Product Change Notification: DSNO-27MYTN998

CCB 7630.001 Initial Notice: Qualification of Double Ring Ag as new lead-frame DAP surface prep material for AT9919K7-GVAO, HV9918K7-G, HV9919BK7-G, AT9919K7-G and HV9967BK7-G catalog part numbers (CPN) available in 8L WDFN (3x3x0.8mm) package at ATP7 assembly site.

CCB 7630.001
Pre and Post Change Summary
PCN #: DSNO-27MYTN998

Lead-Frame Comparison

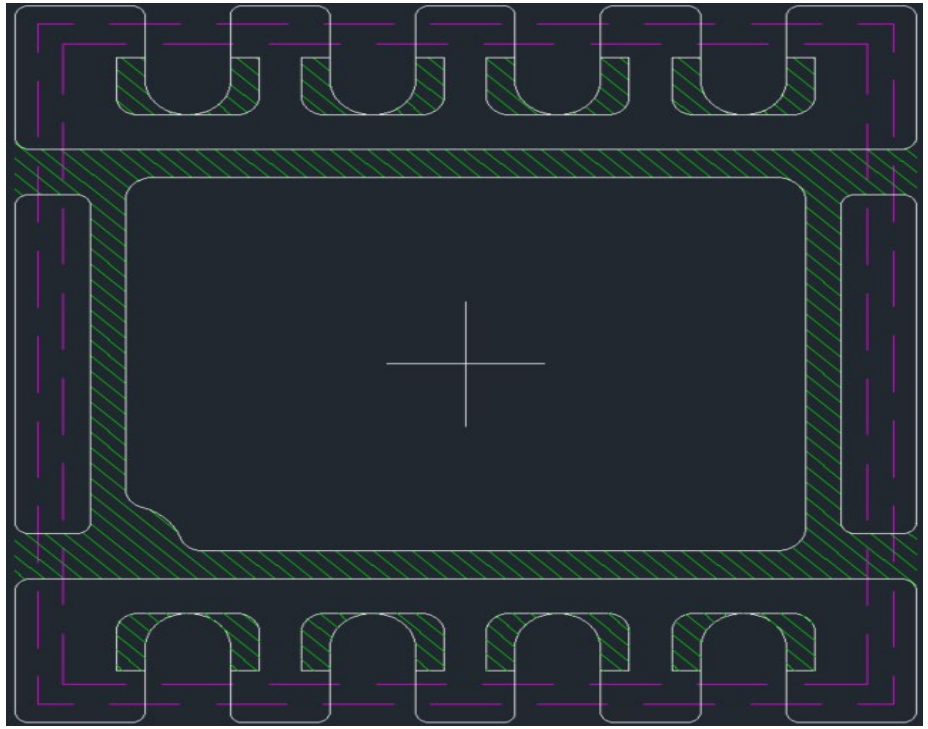
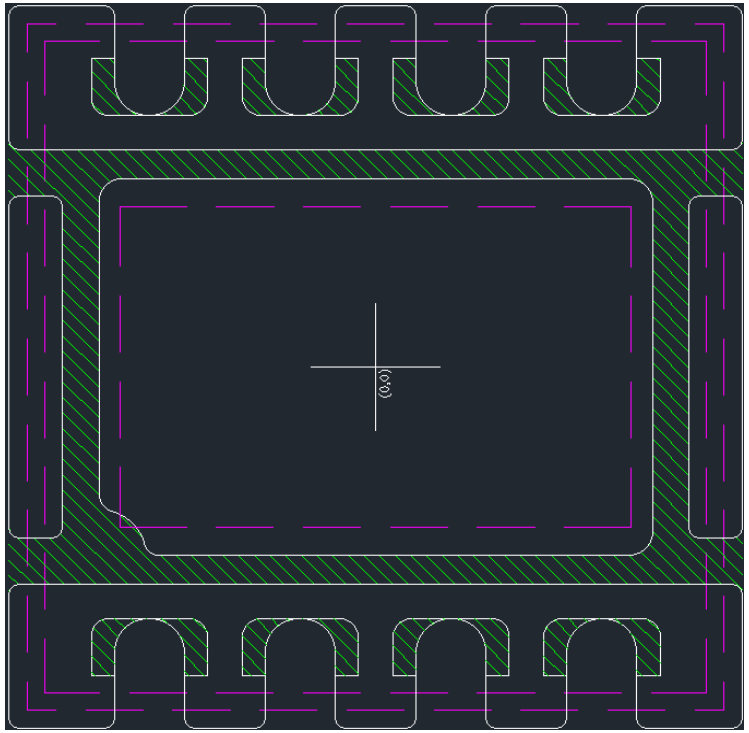
Pre Change

DAP Surface Prep	Ring Ag

Post Change

DAP Surface Prep	Double Ring Ag
